Design N° 2

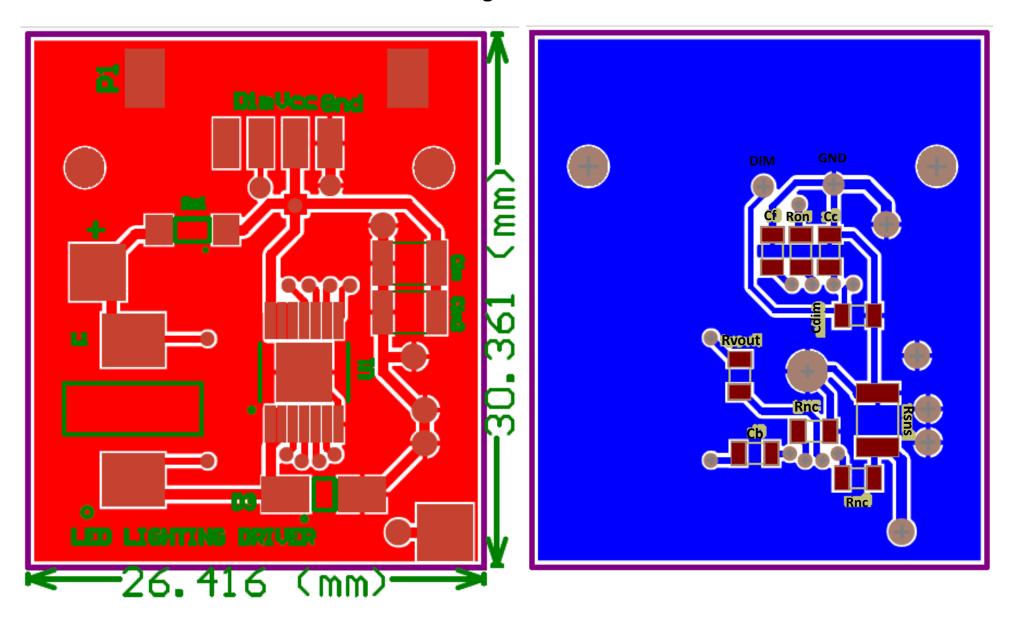
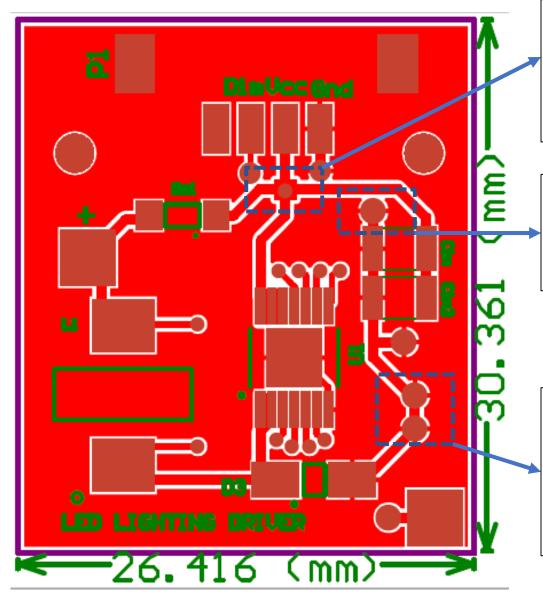
Question 1

I don't know if this node is a good idea. I have read some stuff about PCB connections, but I did not find information that prohibit this.

What do you think?

I put an additional via next to the capacitor with the intention to connect through a direct wire the ground pad. What do you think of this?

Is this path far enough from the other components? I notice that the connections of the vías from the top to the bottom layer are kind of thin (10 [mil] as maximum). Do you think a need to do the vías connections wider?
